MONITORING YEAR 3 ANNUAL REPORT FINAL

WYANT LANDS MITIGATION SITE

WYANT LANDS MITIGATION SITE
Monitoring Year 3 Annual Report

Figures 1a-f
Current Condition Plan View Maps

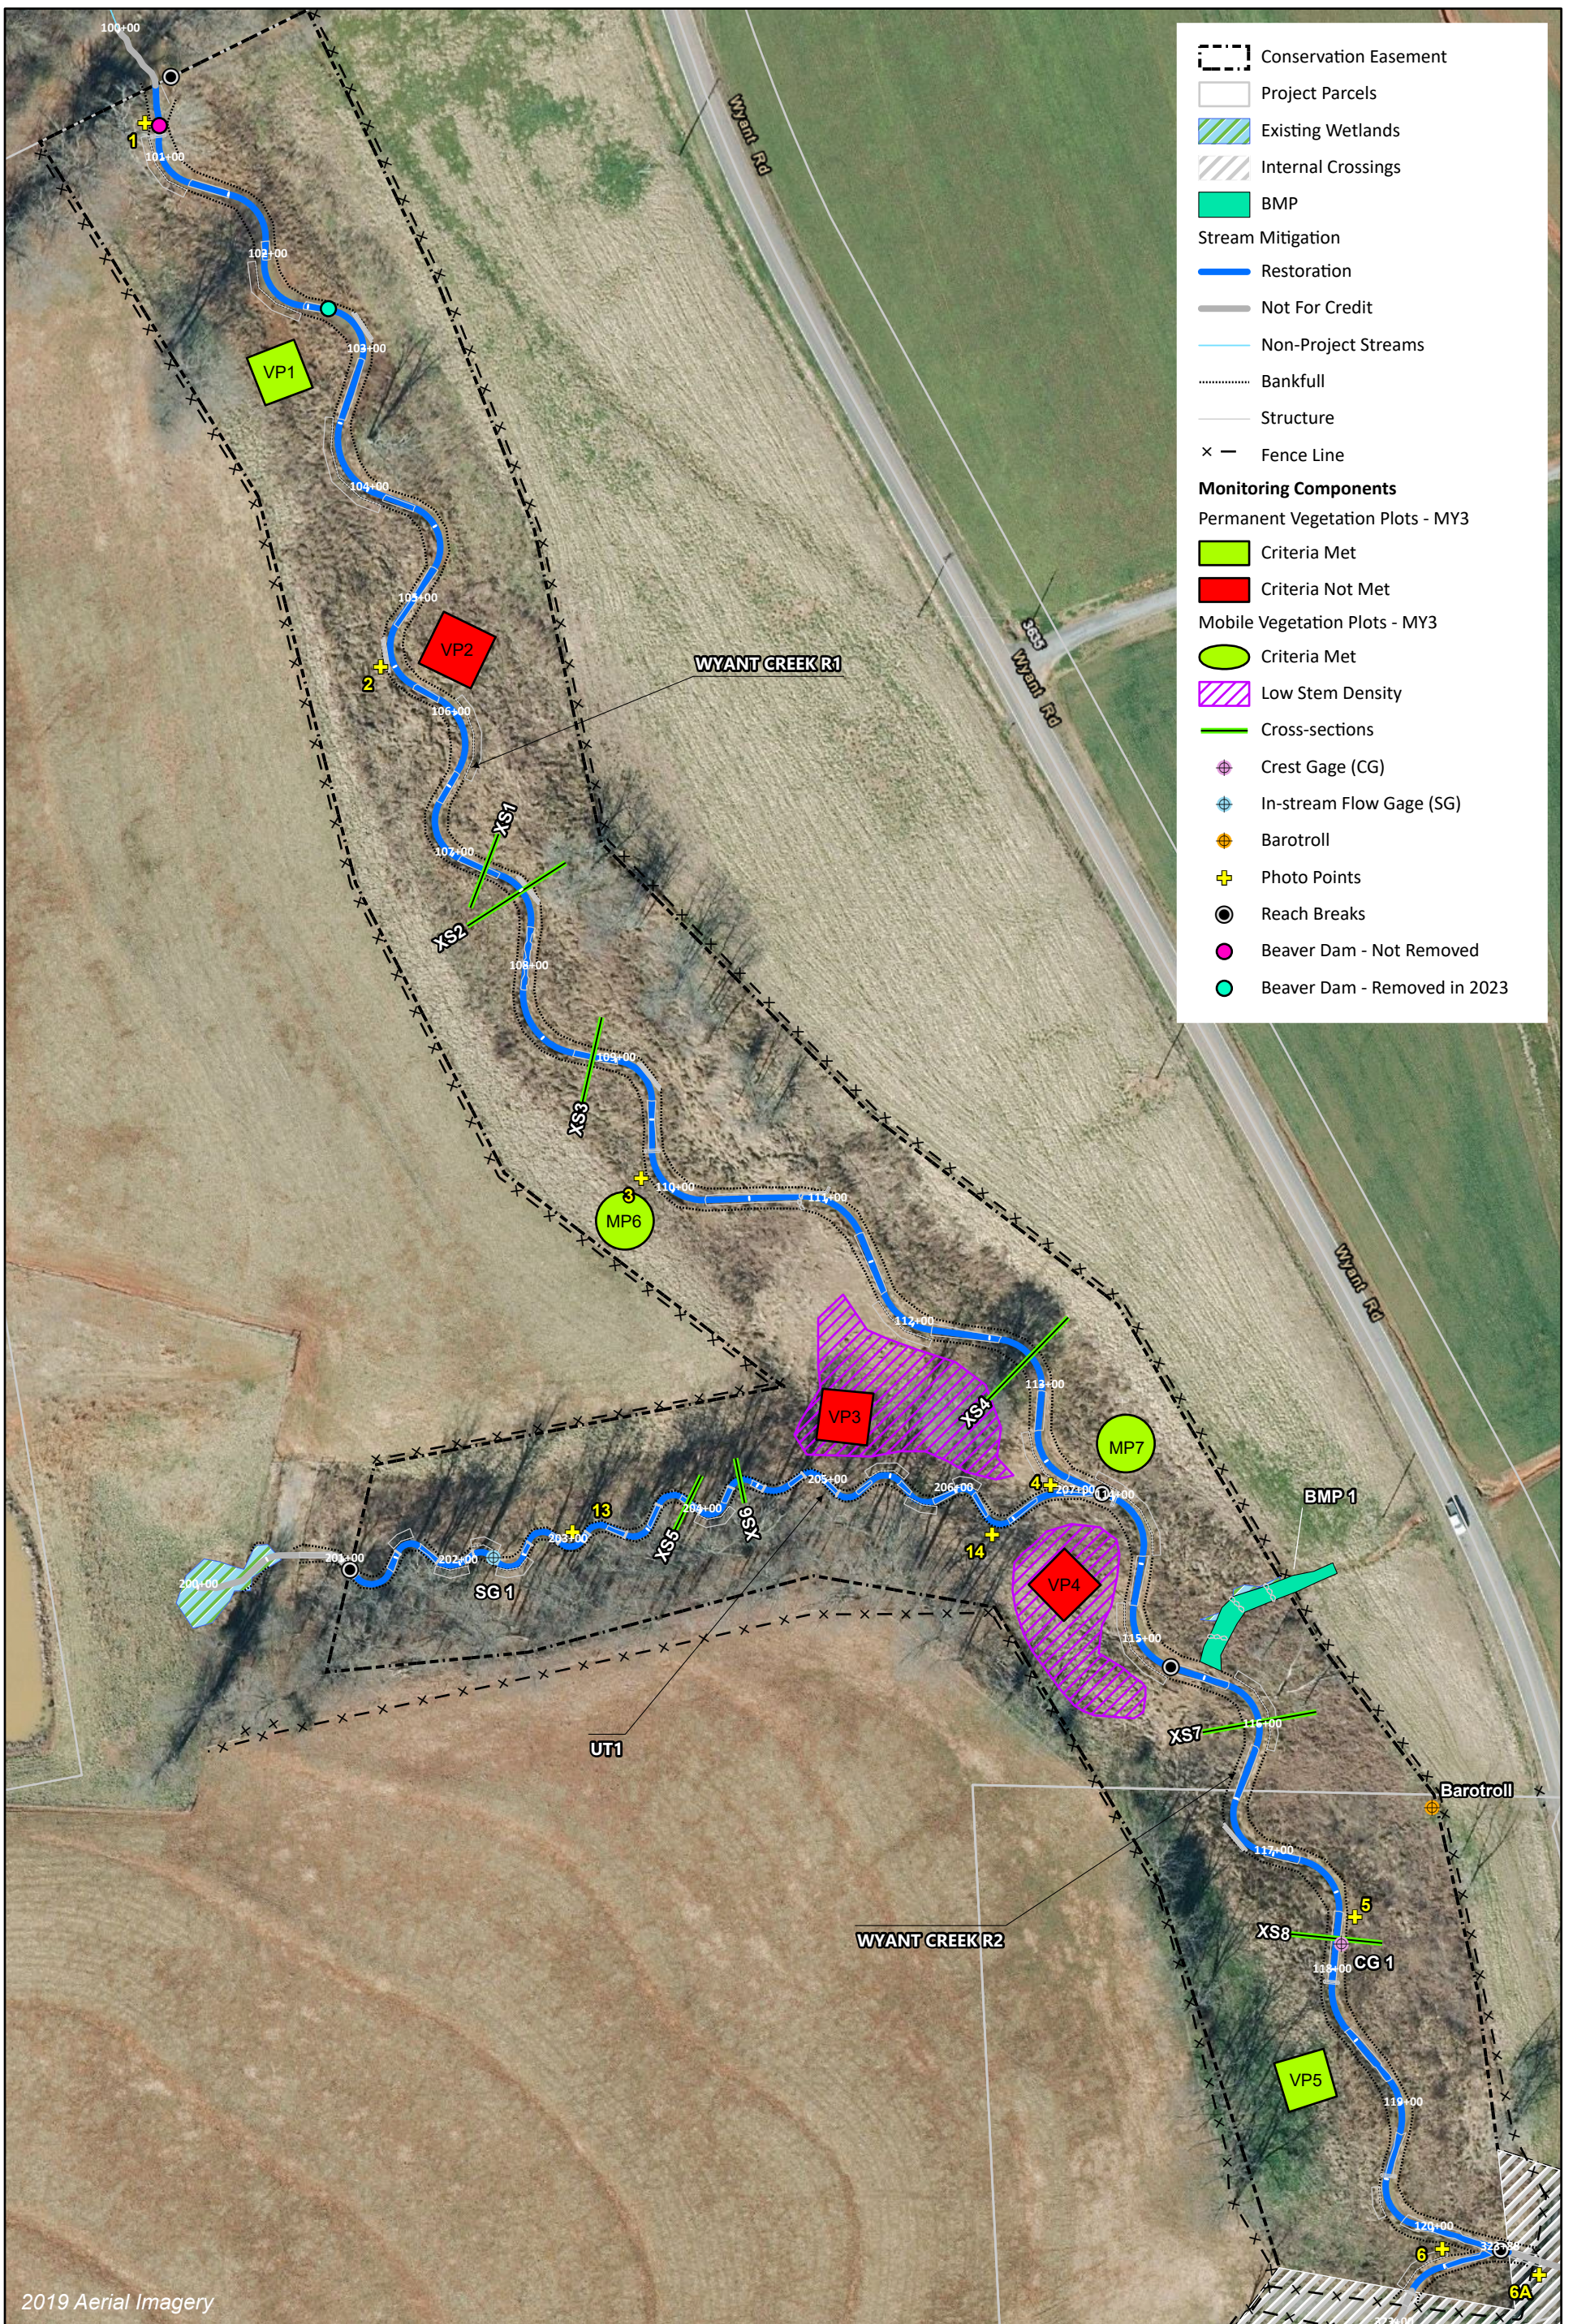
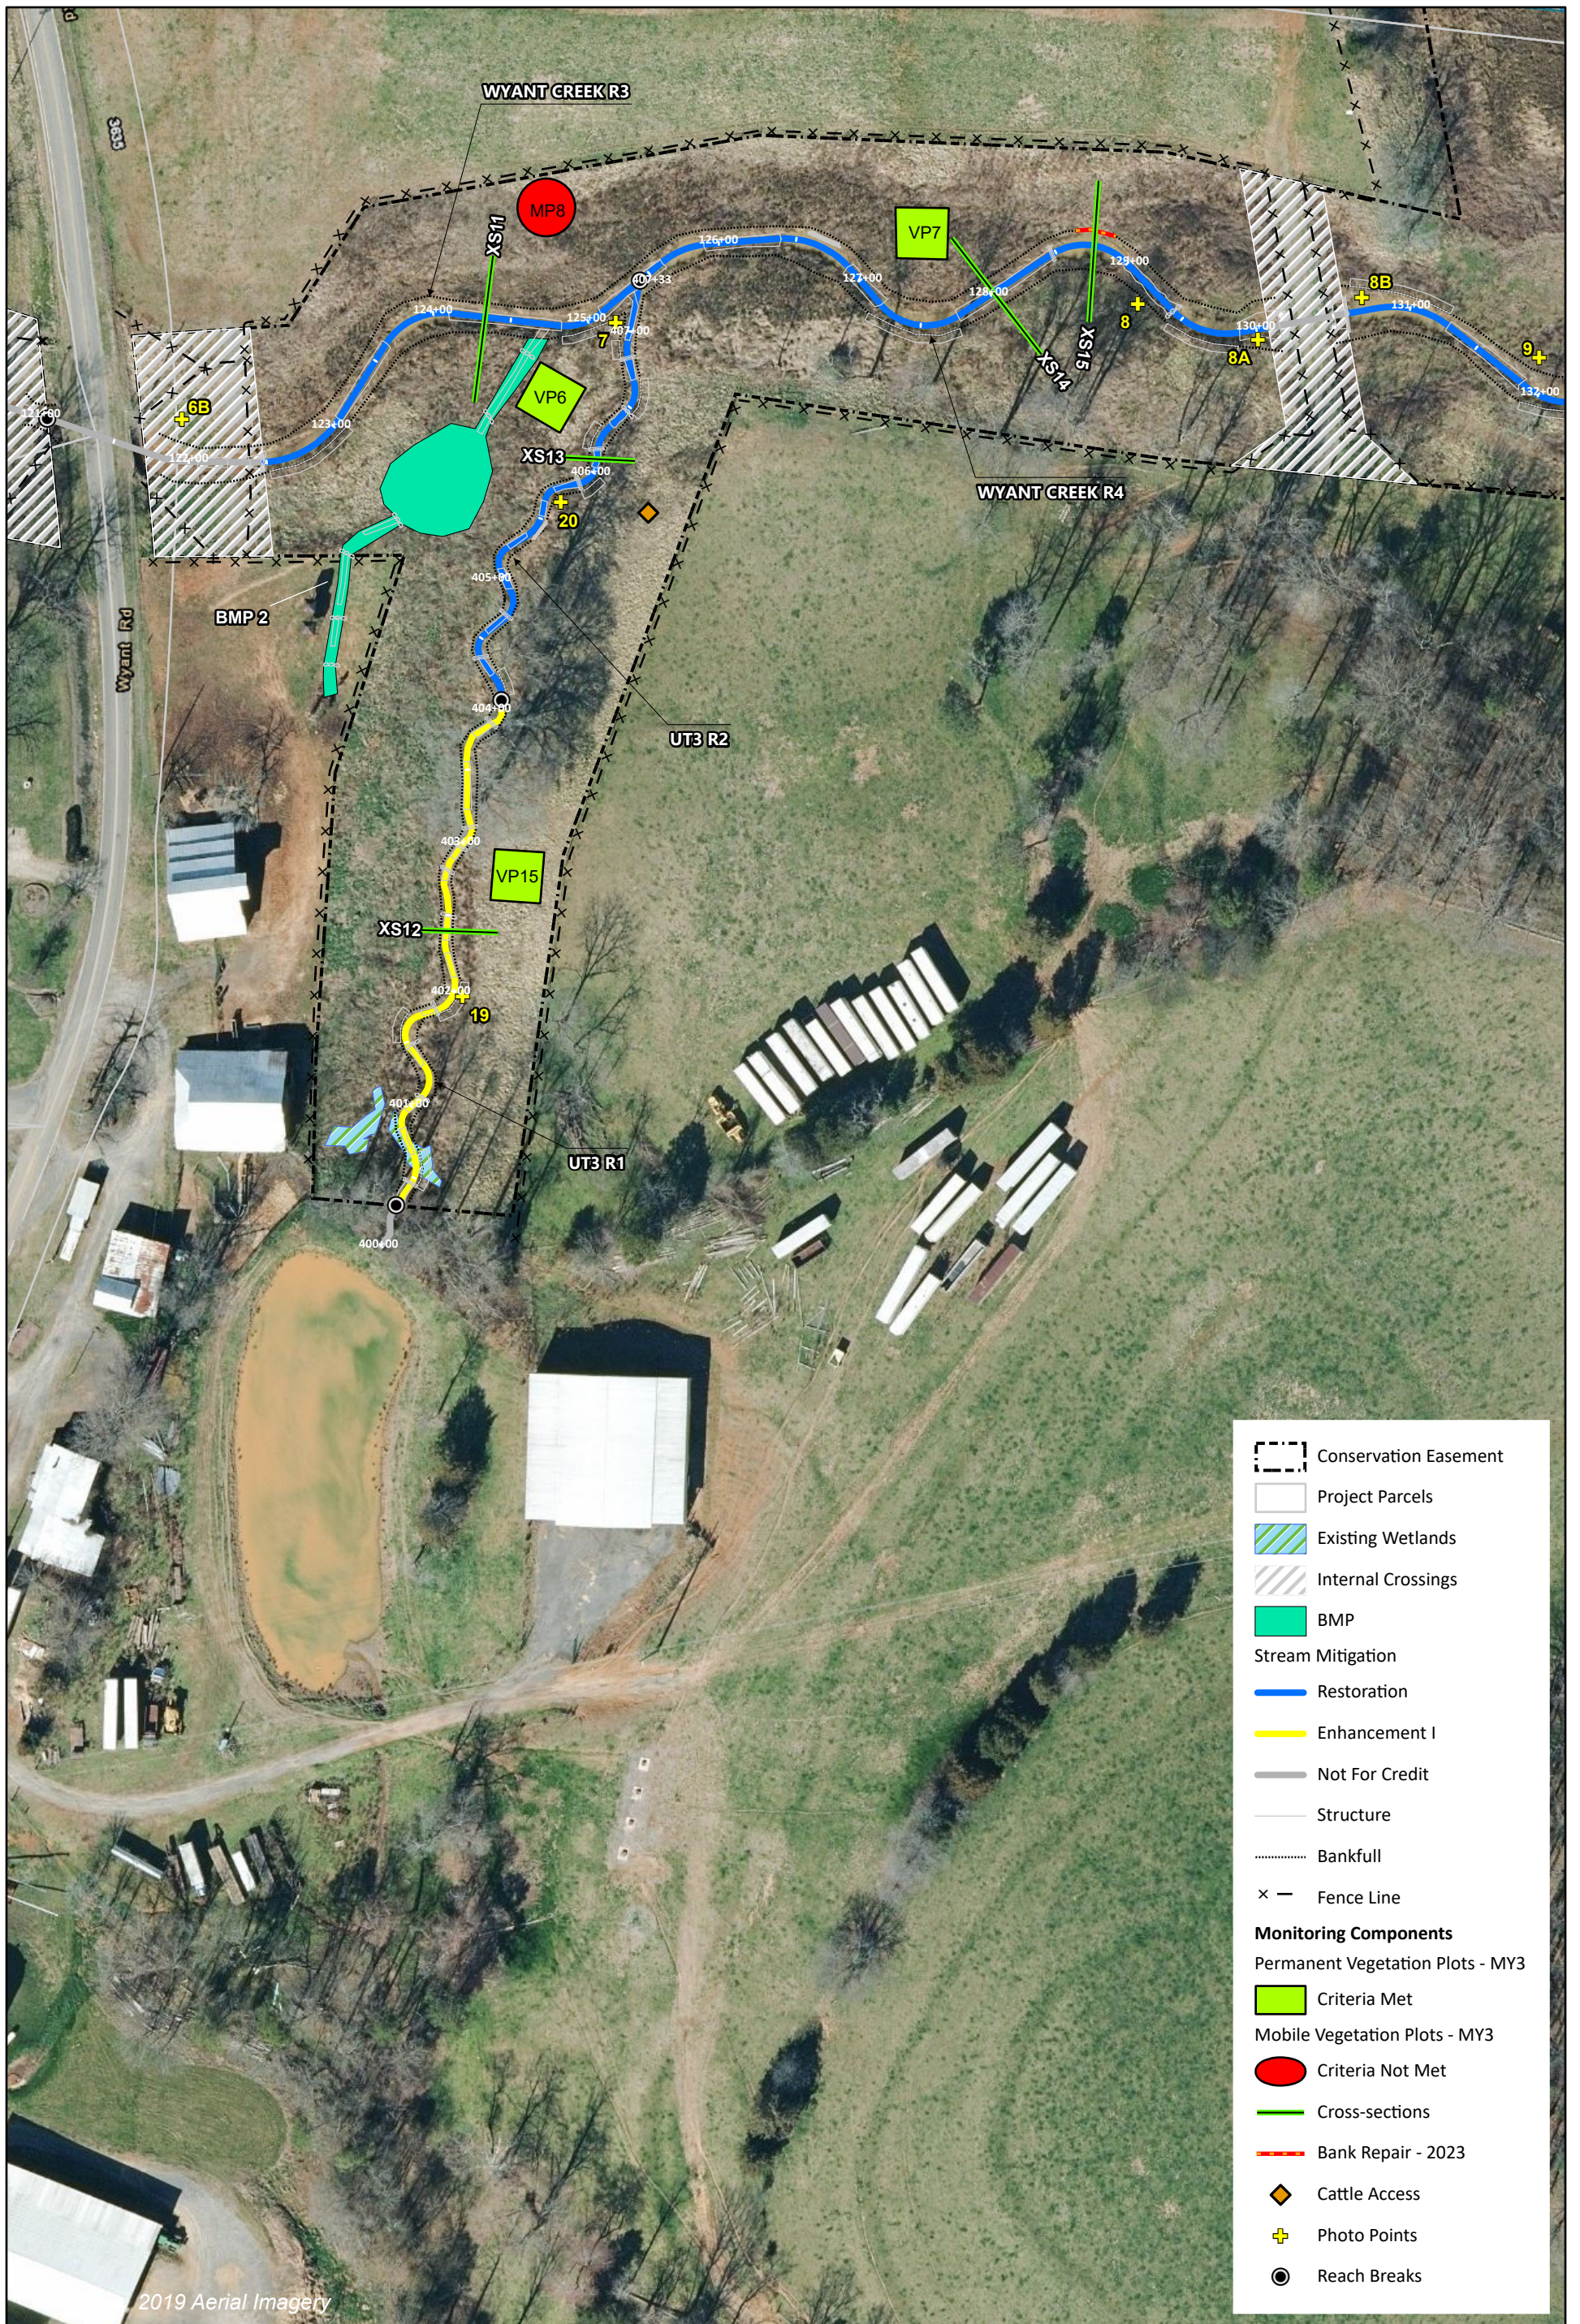
- *Table 1: Project Quantities and Credits; CCPV Maps (Figure 1) & Project Asset Map (Figure 2): There are no wetland IDs on the CCPV maps or asset map. How do the 5 wetland groupings correspond to the CCPV maps (Figure 1) & asset map (Figure 2)? Please identify the wetland groupings on the maps or provide some appropriate description of each grouping in the report text.*

Wildlands Response: Wetland groupings in Table 1: Project Quantities and Credits were updated with their corresponding wetland mitigation categories (e.g., Re-establishment Phase I, Wetland Creation Phase II) for ease of understanding.
